HISTORIC PRESERVATION BOARD STAFF REPORT

Sundy Village – Building A (The Rectory)

Meeting	File No.	Application Type
May 5, 2026	HP-446-2026	Level 1 Site Plan Modification and Certificate of Appropriateness

Proposed detail of hood vents on the roof of Building A (The Rectory)

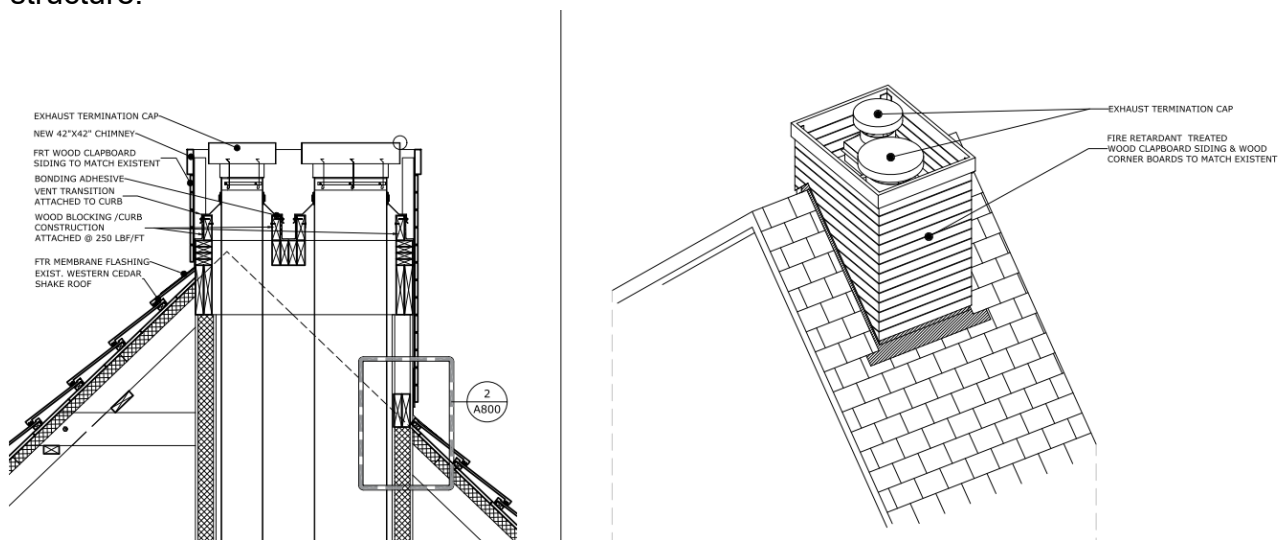
Standards 1, 2, 3, 5, 9 and 10 are applicable to this request. The subject proposal consists of exterior modifications to an existing historic structure known as Building A (The Rectory), located within the Block 61 portion of the Sundy Village site. With regards to Standards 1 and 2, the structure has been preserved on site and is approved for adaptive reuse as a restaurant. With respect to Standards 3, 5, 9 and 10, all exterior modifications to the structures are minor as they include the construction of two new hood vents to the roof and a new design for the screening around the approved mechanical equipment located on the rear (west) roof terrace for restaurant use. The hood vents will be screened with a wood chimney design and will be located on the northwest and southwest ends of the roof (see below). Use of false chimneys is the simplest approach to screening the roof mounted hood vents but could be seen as adding conjectural elements to the structure (Standard 3). The mechanical equipment on the roof terrace is proposed to be screened with a new wood enclosure, designed to match the existing wood siding of the structure which is expected to be compatible with the architectural detailing of the structure.

Proposed detail of mechanical screening on the roof of Building A (The Rectory)

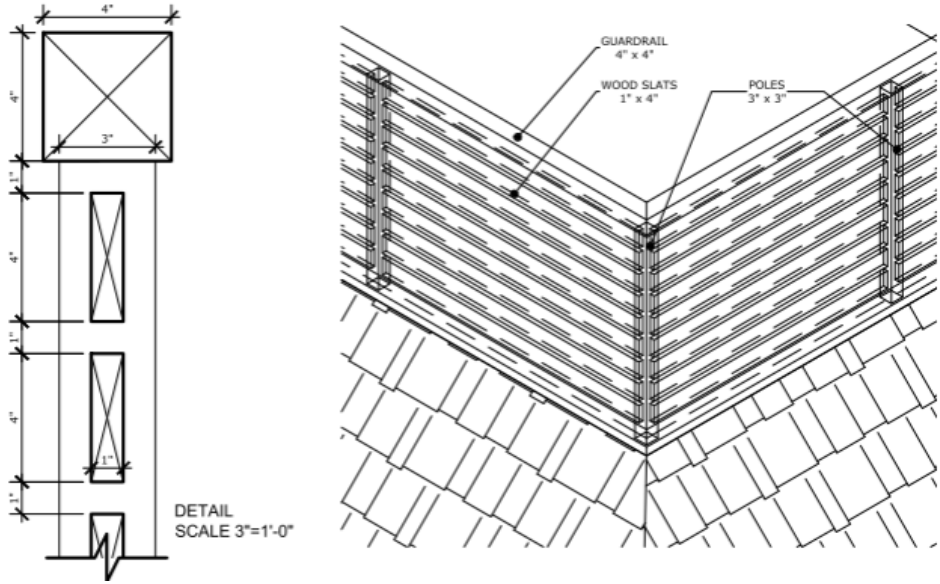
As for **Roof Shapes**, there are no proposed changes to the roof shapes for the subject structure, however it is noted that two hood vents will be placed on the roof to the rear (west) sides of the building, where they will be the least visible from the public right-of-way and so as to not interfere with the historic integrity of the front façade. Their designs will appear to look like chimneys. Given the constraints of converting a structure that was originally designed for residential use to a restaurant, the proposal represents the least impactful architectural approach. There are no concerns with the proposed roof modifications.

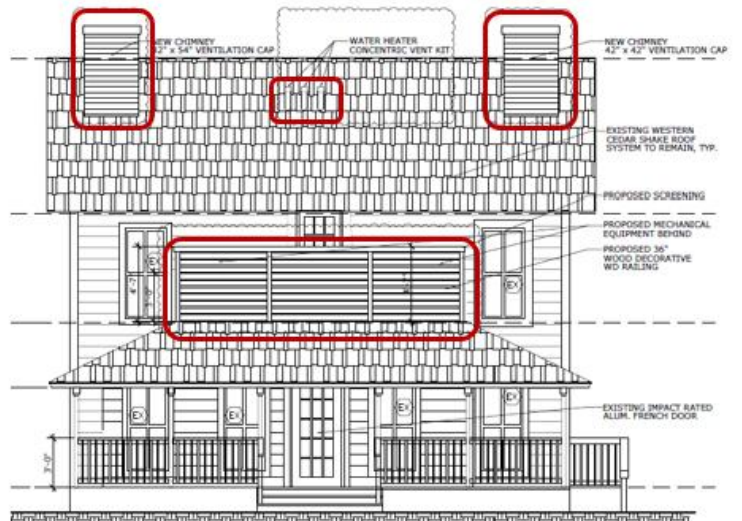
Regarding the exterior changes to the existing windows on the northwest side of the first floor of the structure, the proposal has been designed with decorative blinds inside of the window and a wall to be constructed on the interior side of windows to allow for more kitchen area of the restaurant. The blinds will be visible from the exterior of the structure to provide the windows an appropriate residential appearance. The glass will remain clear to match the existing windows and the windows will be operable on the exterior, to allow for future maintenance or cleaning functions.

It is noted that the modifications to the windows will completely conceal them on the interior, which is not considered an ideal modification to the historic structure. However, there is no concern with regards to any permanent damage to the structure as the interior sheathing can be removed in the future and would not diminish the historic integrity of the structure. The board will need to determine whether the modification is appropriate to the historic structure.

Proposed rendering of mechanical screening & new hood vents on the rear (west) Elevation of Building A (The Rectory)

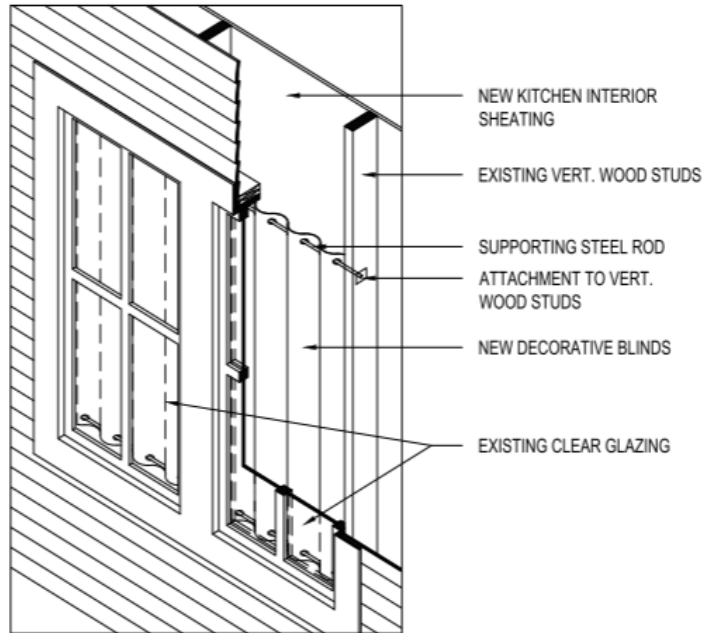
With respect to **Relationship of Materials and Color** the proposal includes two new hood vents on the roof to be designed within false chimneys that will be clad with wood clapboard and siding to match the existing structure. It is noted that the original hood vent approval had Hardiboard material for the proposed hood vent screening for Building A (The Rectory), which is no longer being used for the structure.

The proposed screening for the approved mechanical equipment located on the roof terrace located on the rear (west) side of the structure will also match the existing wood siding in material size and color where a fence railing was approved.
